## ORIGINATION FORM

### Proposed Revisions to a Standard Plans Index (Please provide all information — Incomplete forms will be returned)

Index Number: 515-080

Index Title: Pipe Guiderail (Steel)

TYPICAL SECTION ON CONCRETE SIDEWALK

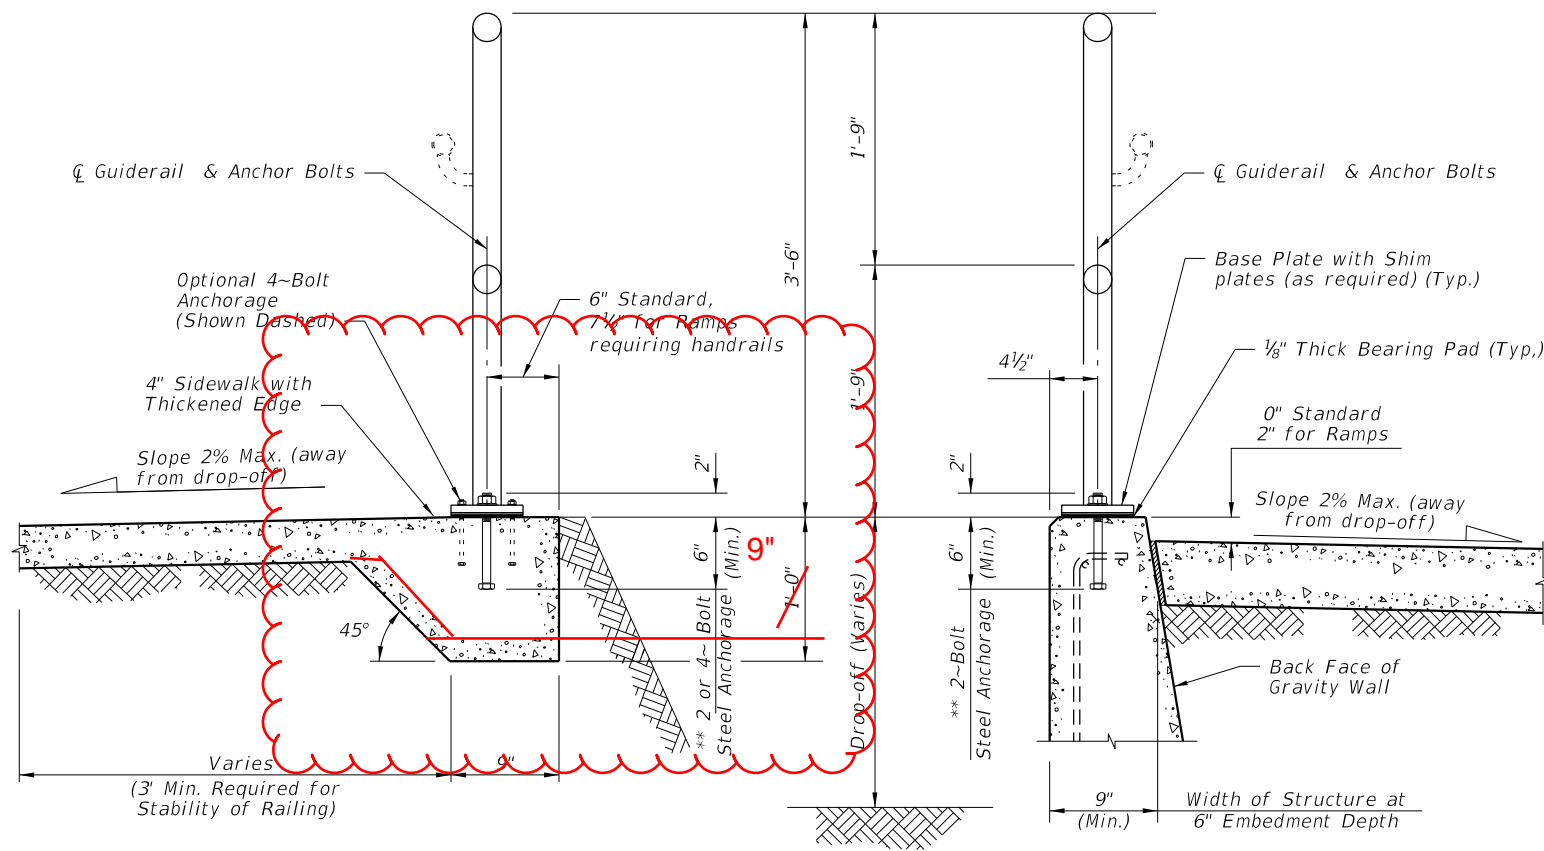
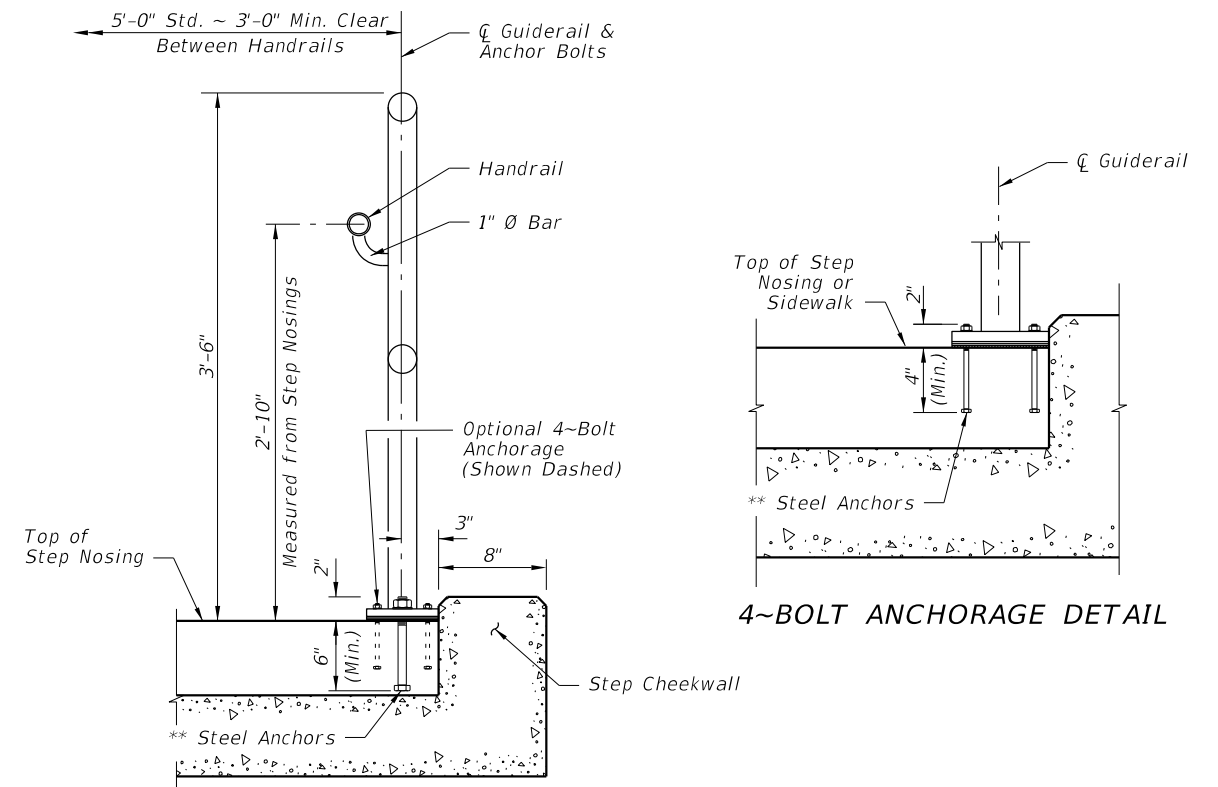
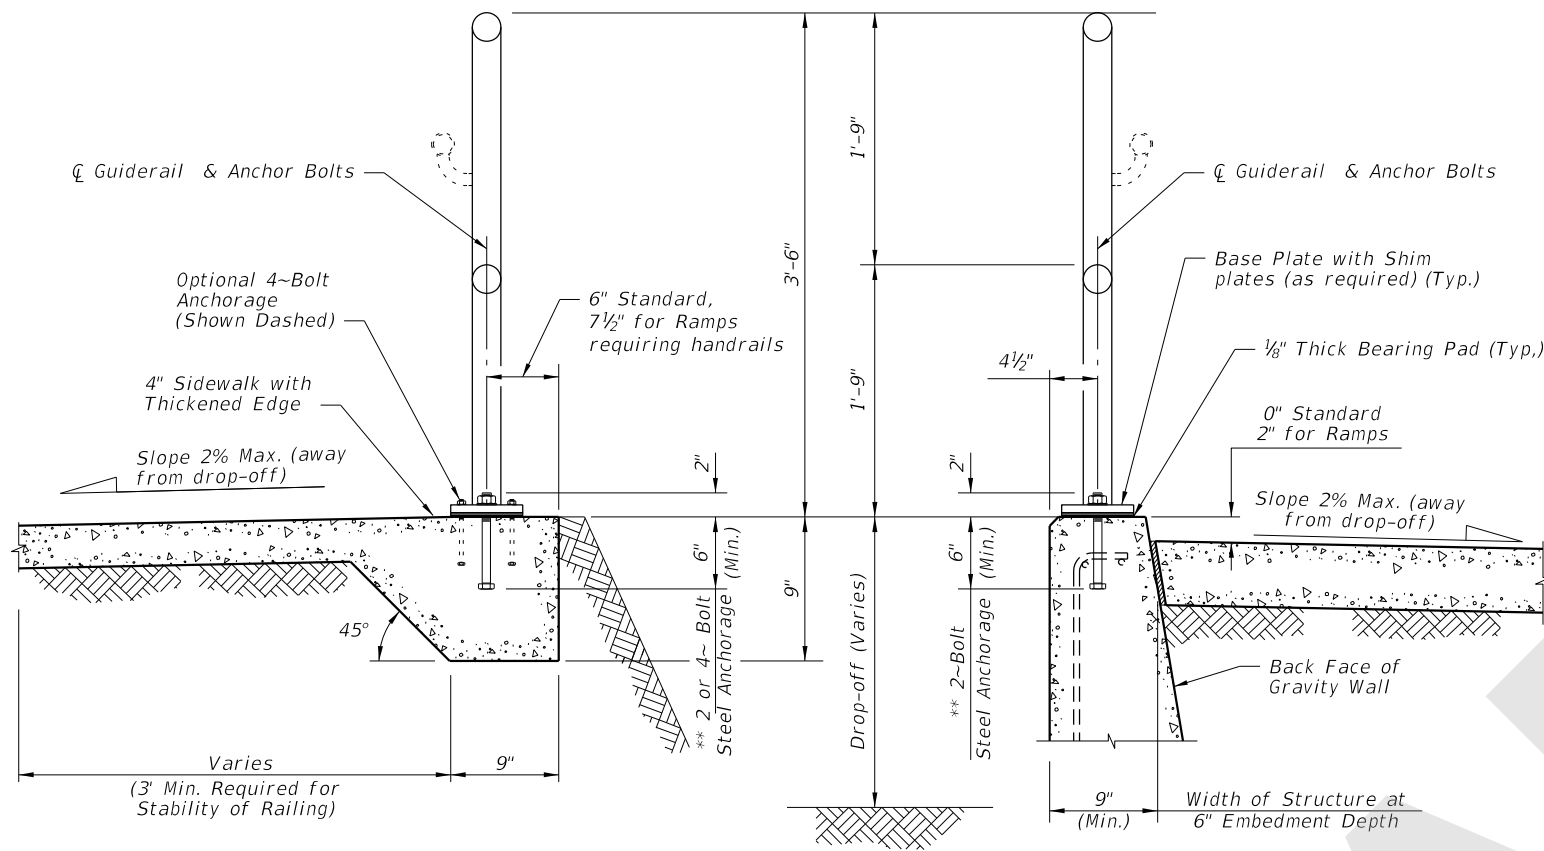
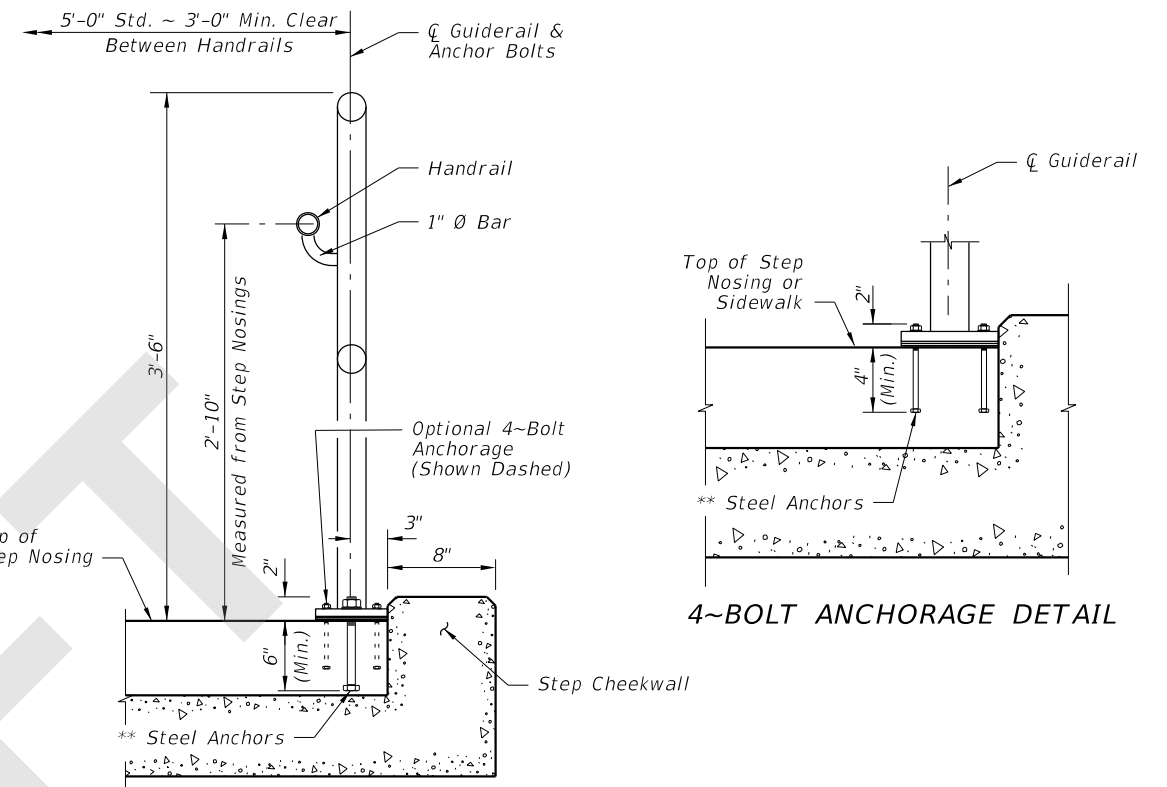
Change edge beam of sidewalk to 9" deep.

Due to research, embedment was reduced to 6"; therefore, the depth can be reduced to 9".
